Ian Doyle  
Director of Service Delivery  
Guildford Borough Council  
Millmead House  
Guildford, GU2 4BB

11<sup>th</sup> February 2021

**20/P/02155 | Hybrid planning application for the redevelopment of part of the allocated site for the Slyfield Area Regeneration Project for a mixed-use development (known as Weyside Urban Village)**

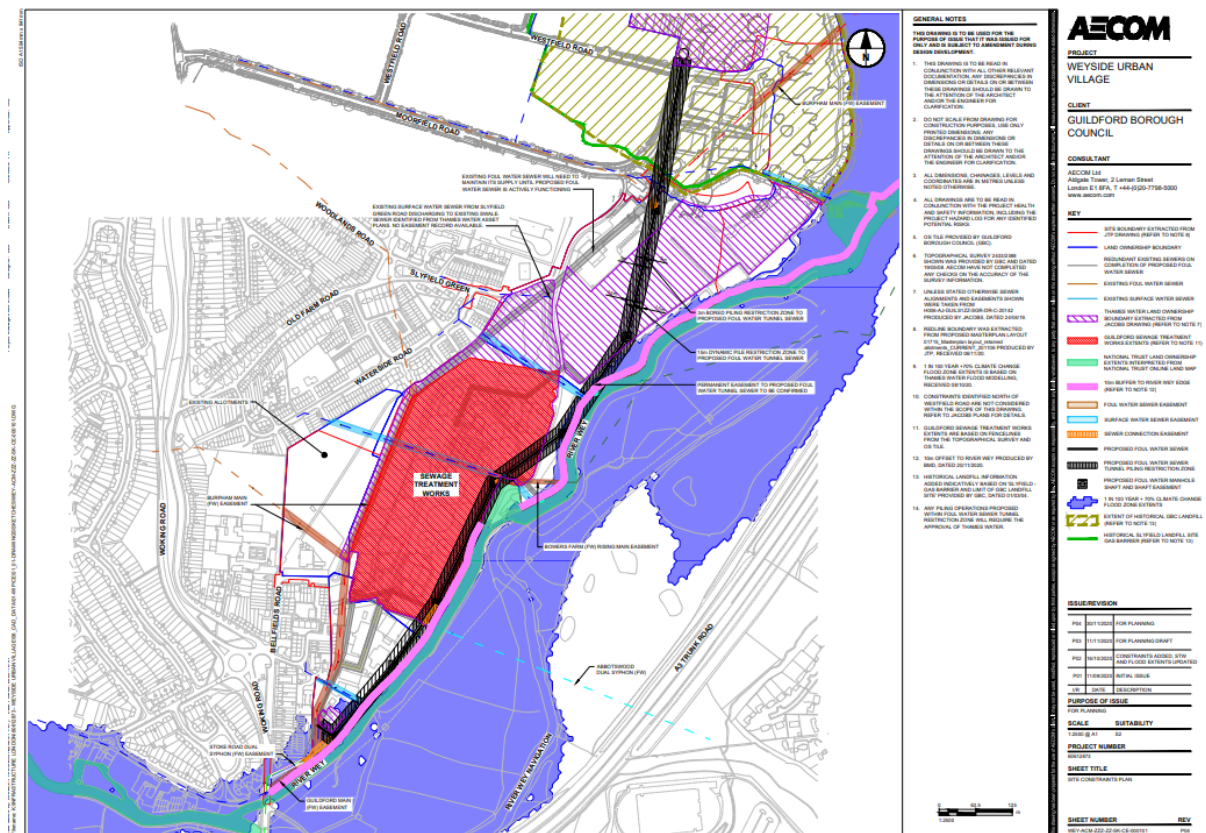
The submitted plans are silent on the matters highlighted in the revised NPPF, does consideration need to be given to making sure flood resistant ground floors are provided if there is a danger of flooding.

The Site is low lying and depends on good drainage to keep Ground Water Levels at an acceptable level. Although the site has three green corridors leading to the river these are replacing a considerable area of currently scrubland with hard surfaces abounding on the adjacent built areas. The green corridors are also crossed by a major transport corridor in the form of the spine road and various footpaths.

The new Sewer, which is a large structure that links the existing Sewer mains to the new STW at the north of Slyfield runs for a length along the River. This could potentially block subsurface drainage to the river causing the site to have rising ground water levels, has this been modelled?

We are uncertain Flooding issues are properly understood for the site.
